RE: Appeal of Denial of Request for an Exception to provide 37.5' wide easement in lieu of 50' wide easement and to provide 12' wide pavement in lieu of 20' wide pavement for an access easement.

Layout Plan Application (City File #13PL005) to create Lot AR-1 of Lot 4R, Lot AR-2 of Lot 4R and Lot 5R-1 of Block 15 of Canyon Lake Heights Subdivision, Section 8, T1N, R7E and Section 9, T1N, R7E, Rapid City, Pennington County, South Dakota.

**REQUEST FOR EXCEPTION TO
RAPID CITY DESIGN STANDARD / CRITERIA / REGULATIONS**

REQUEST FOR EXCEPTION TO RAPID CITY DESIGN STANDARD / CRITERIA / REGULATION

PLAT OF
LOT AR-1 AND AR-2 OF LOT 4R OF BLOCK 15,
AND LOT 5R-1 OF BLOCK 15,
CANYON LAKE HEIGHTS SUBDIVISION,

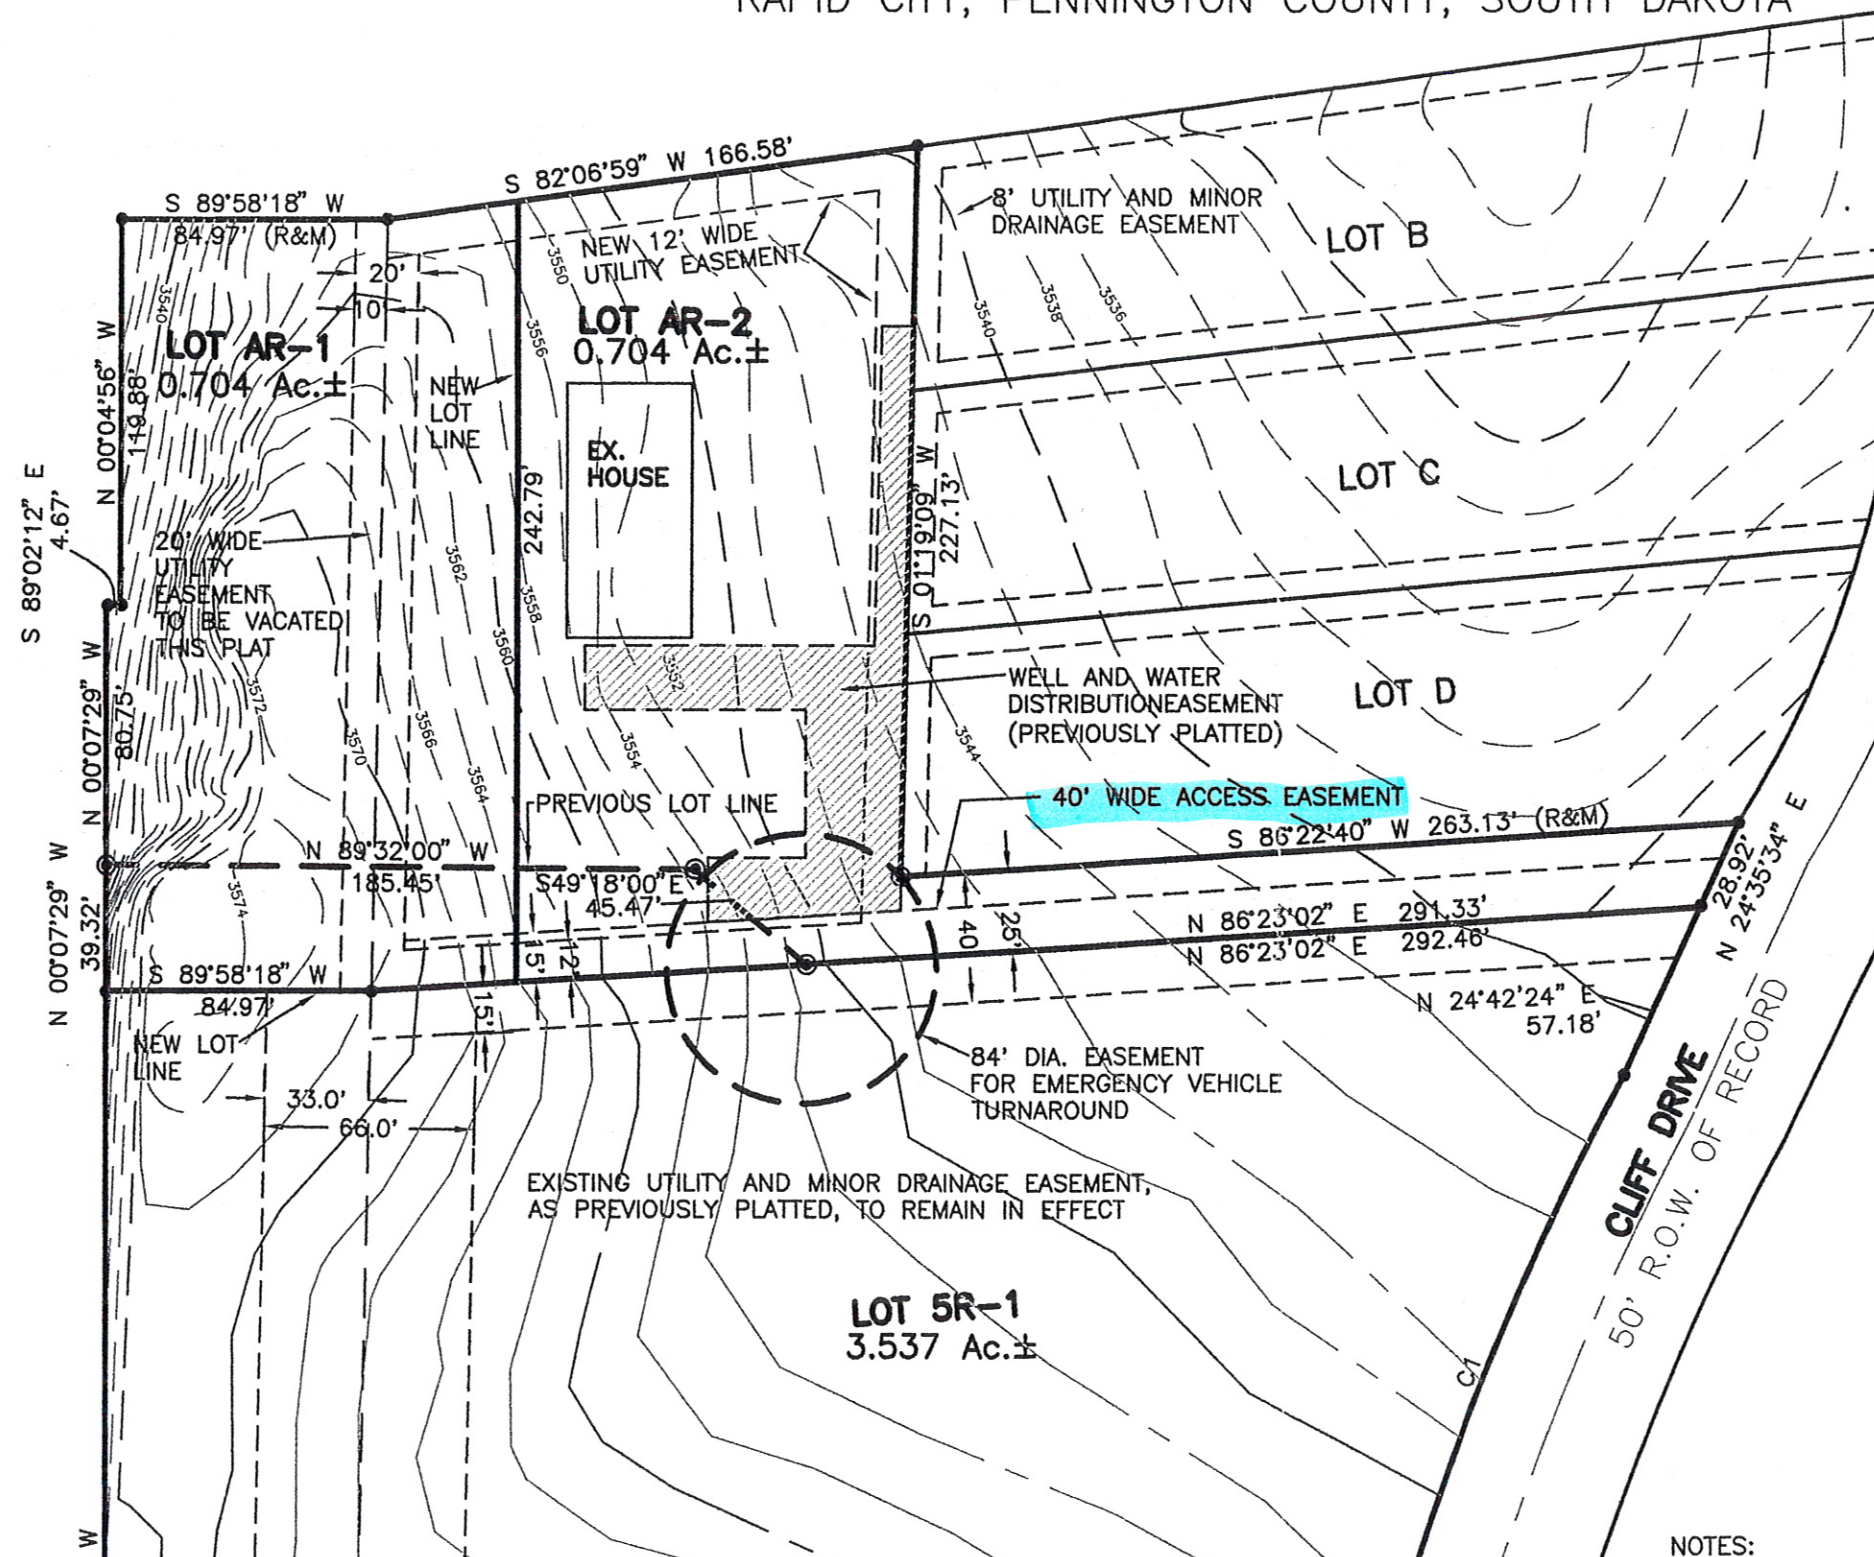
NAL Redlines
1/23/2012
